Letter I1a

Mark Slovick
 Planning and Development Services-San Diego County
 5510 Overland Ave. Suite 110
 San Diego, California 92123

Lilac Hills Ranch is poorly designed. Also it is not very safe. After reading the EIR concerns I have include...

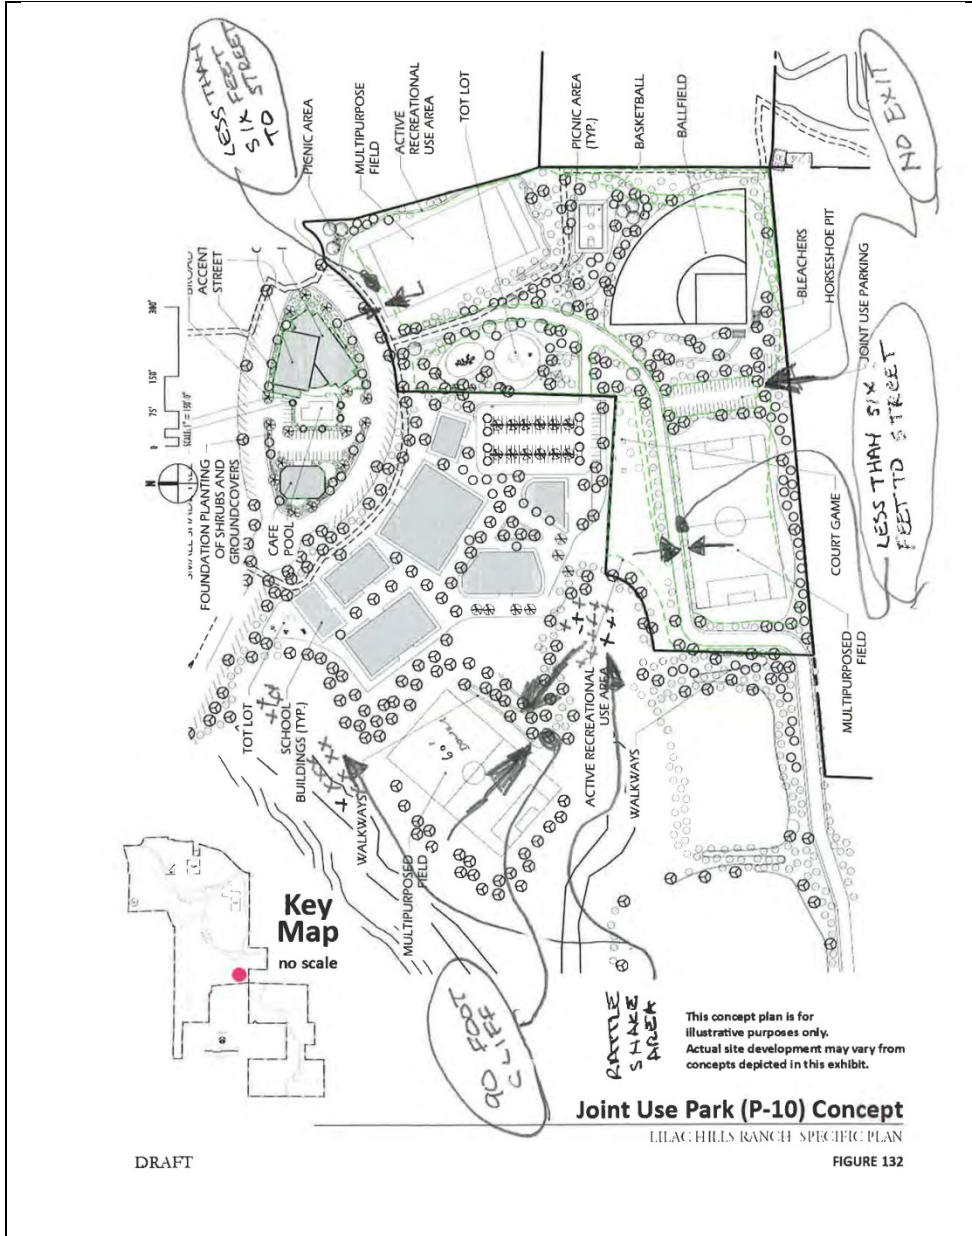
A. Why would a church want two athletic fields unless it is also a private school. What church would want to build on a site that cannot be easily accessed because it would be behind two locked senior citizen gates? How would the kids get to this private school? Accretive needs to explain this and show that an interested, willing and financially able church is ready to build.

The Specific Plan identifies that the 10-acre Institutional Use site may be developed for uses such a church or other civic use. The schematics provided are for illustrative purposes only and do not represent the actual development proposal. The specific uses on the Institutional Use would be subject to future permitting and discretionary review.

Comments 9B through 9E raise issues about the proposed land uses within the Specific Plan (such as recreational club/gym, new school, group care, motel) and the feasibility of these land uses to occur on the site. One point of clarification is that only the southern half of the Phase 5 (SFS-5 and SFS-6) of the senior community would have restricted access. Access to the church site would be unrestricted.

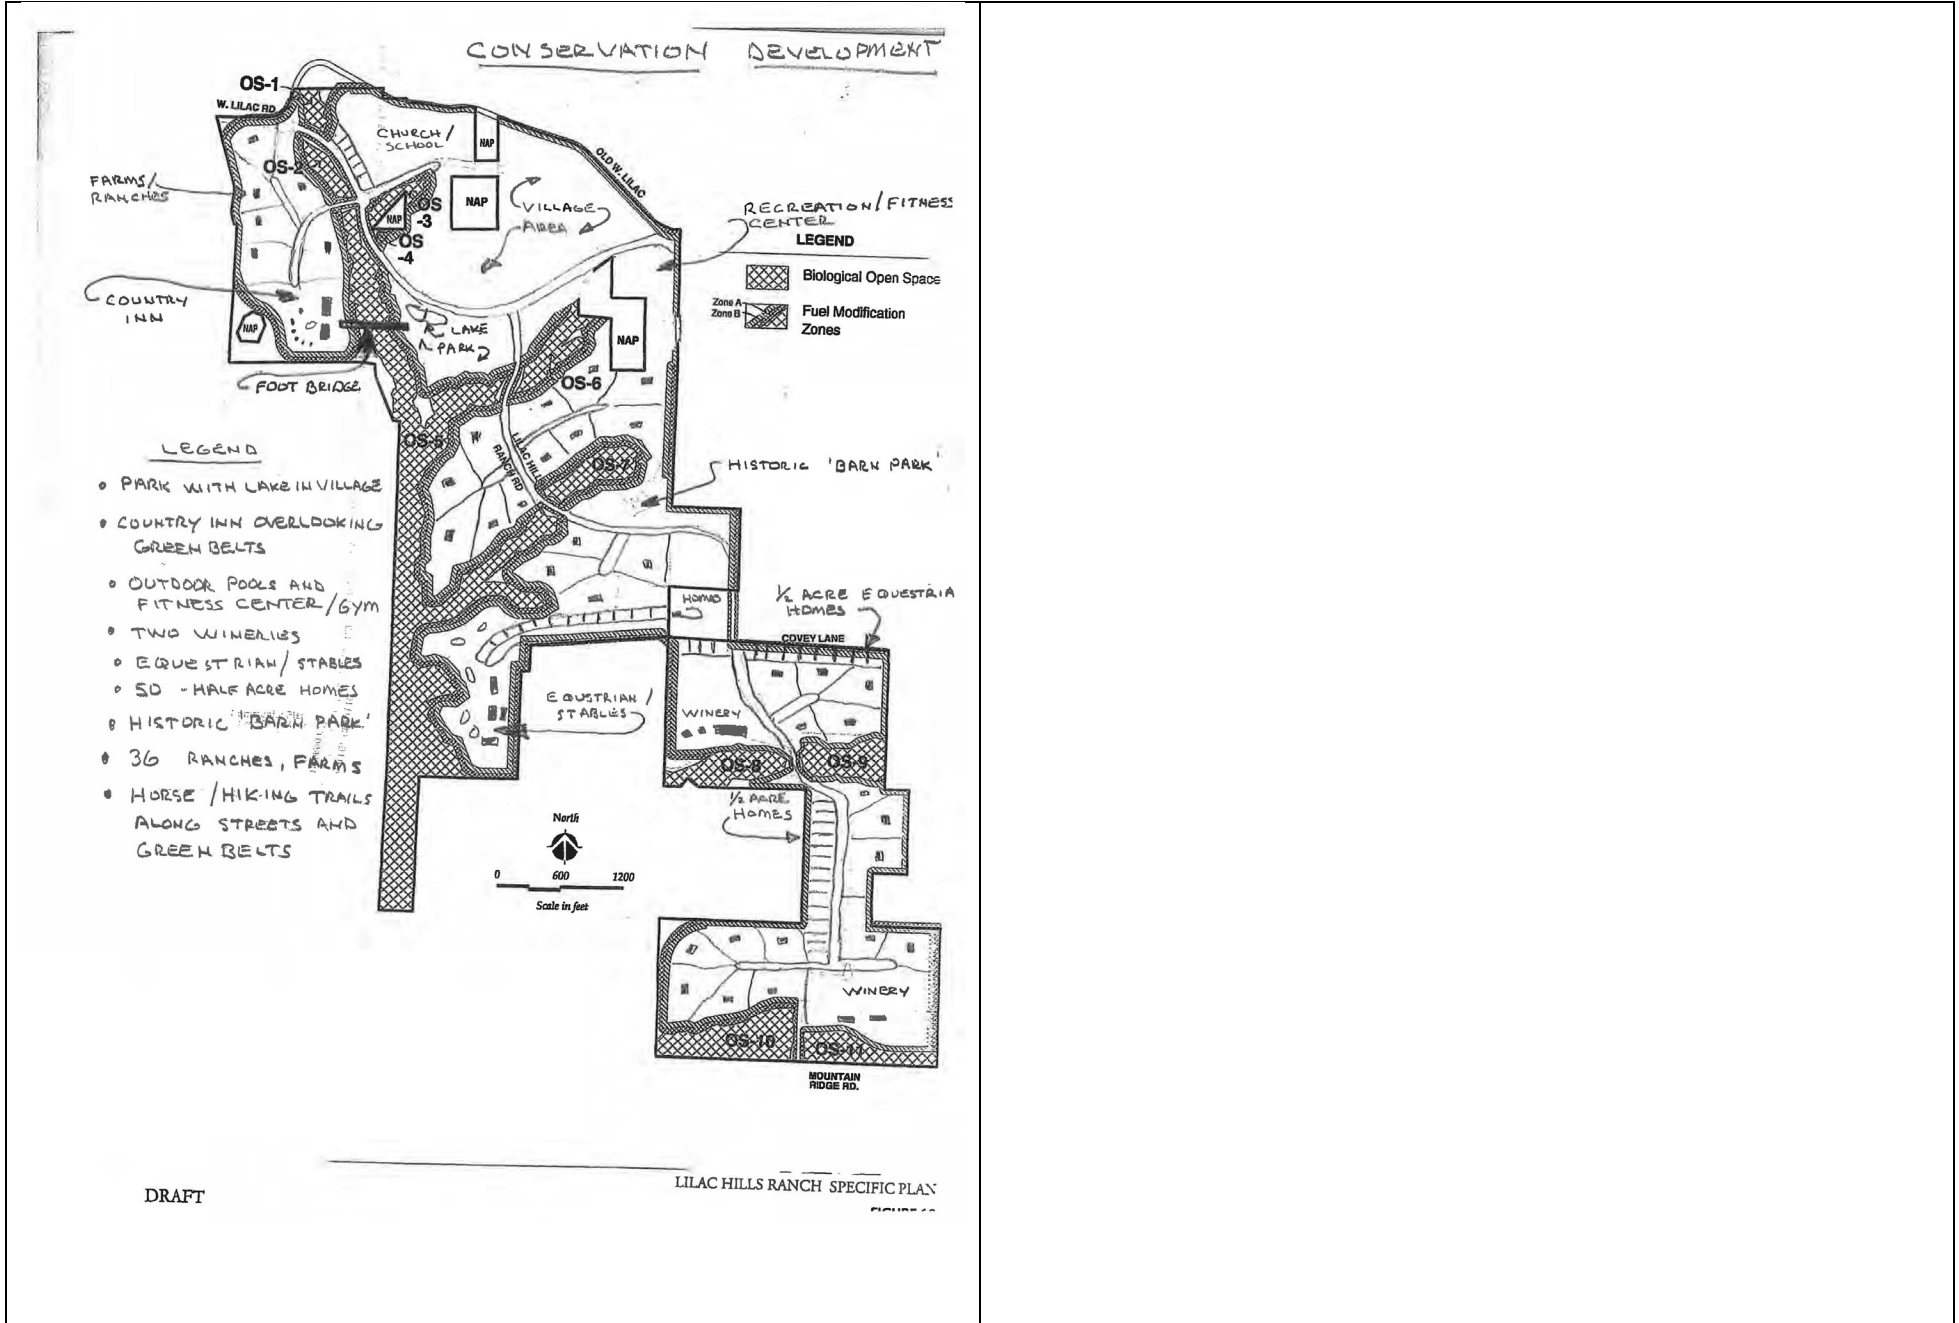
Using the concepts used in Colorado a much more desirable village could be developed. The town village could be a little larger with more green belts and open spaces. The country inn and most of the town would surround a small lake. The down town village area has much larger plaza areas. The condos and townhomes would be buried with more landscaping, and parking lots are better hidden from the street views. Single family homes would be in 'six packs' surrounded by greenbelts eliminating the boring streets scenes. Outside of the village area are many equestrian half acre estate homes next to horse trails. The majority of the 608 acres would be open space or small farms/ranches. Lilac Ranch would bisect the project connecting to all the farms, ranches, church/private school, community center, and vineyards. Horse and hiking trails would surround the entire project and streets. An equestrian center/ stables would be in the south west corner. See attachment for pictures.

The comment does not raise an issue related to the adequacy of the environmental document. The commenter provides an alternative development option referencing concepts used in Colorado and an attached development schematic. This information will be included as part of the record and made available to the decision makers prior to a final decision on the proposed project.

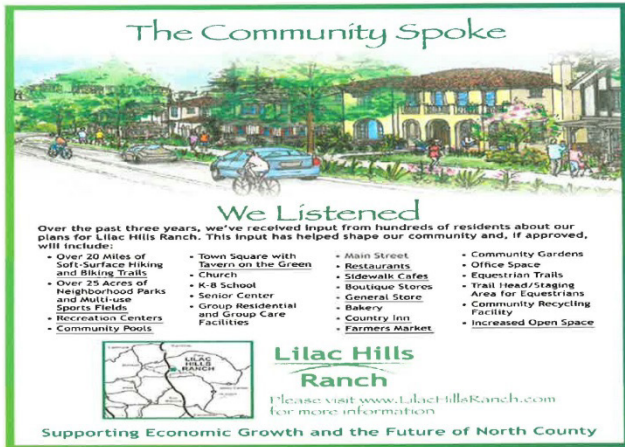
These statements and others that appear on Lilac Hills Ranch web site or in the Specific Plan are very deceptive. I do not see an amphitheater anywhere in the documentation except for a small concrete step next to the sidewalk in the town square. If it 'promotes walkability' why is the senior housing over one mile away from the town center? How does it 'preserves our rural character' when 1746 homes are built of 250 acres which is denser than most major cities? 'Conserving open spaces' are just the gullies that are impossible to develop. No land is being conserved. The marketing word for gullies is 'Biological Open Space'. How does planting a row of avocado or orange trees on a cut slope conserve agriculture?

Along with these false statements the pictures of their web site and in the Specific plan are very deceptive. For example ;

I1e-1 The first five pages of this comment letter refer to statements and graphics that appear on the Lilac Hills ranch website. As these graphics and statements are not representative of information contained within the FEIR, these comments do not raise environmental issues or provide information that conflicts with information contained in the FEIR. The Lilac Hills Ranch website was provided for purposes of public information during project development and does not necessarily reflect the project that has been presented in the FEIR. These comments will be included as part of the record and made available to the decision makers prior to a final decision on the proposed project.
